**Village of Arlington Heights  
Building & Life Safety Department**

**Interoffice Memorandum**

**To:** Sam Hubbard, Development Planner, Planning and Community Development  
**From:** Deb Pierce, Plan Reviewer, Building & Life Safety Department  
**Subject:** Arlington 425 – PUD, Preliminary Plat of Subdivision, Rezoning from R-1 to B-5, LUV for Apartment Building, Variations  
**PC#:** 19-001 – Round 1  
**Date:** January 23, 2019

**PLAN COMMISSION PC #19-001**  
**Arlington 425**  
**PUD, Preliminary Plat of Subdivision, Rezoning from R-1 to B-5,**  
**LUV for Apartment Building, Variations**  
**Round 1**

REMOVABLE HOOD basin and water  
quality structure DETAIL

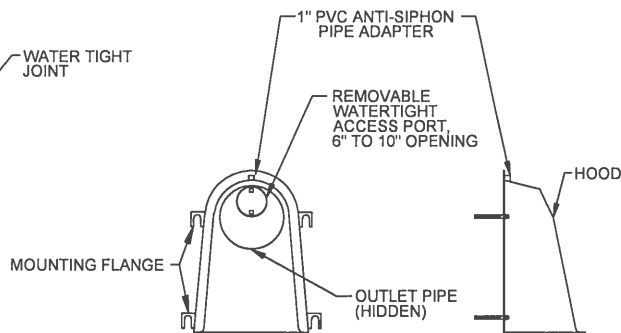
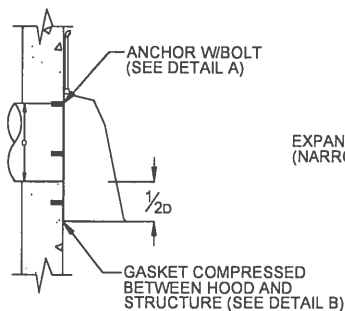
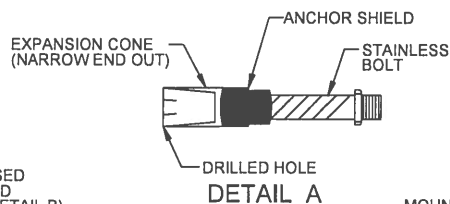
4" must be in a trap in a catch basin. Regarding the hood, for reference is a removal hood detail from the Metropolitan Water Reclamation District. Provide a detail showing the restrictor catch basin.
